**IC693CPU351**  
**New In Stock!**  
**GE Fanuc**

# IMPORTANT PRODUCT INFORMATION

**Product: Series 90-30 CPU Module with Firmware Release 9.11  
IC693CPU351-KT**

GFK-1747G

### Battery Life

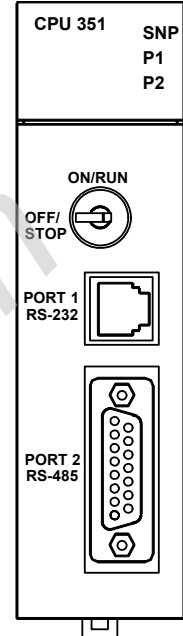
This hardware revision replaces an obsolete cache RAM with a component that is currently available. At room temperature, the new part reduces the battery life from 6 years to 10 months.

The new cache RAM component reduces the battery life as shown in the following table. This information will be included in the next scheduled update of the *Series 90-30 CPU Reference Manual*.

Hardware Version	Estimated Battery Life	
	at 25°C	at 60°C
IC693CPU351-Hx and earlier	6 years	1½ years
IC693CPU351-Kx and later	10 months	5½ months
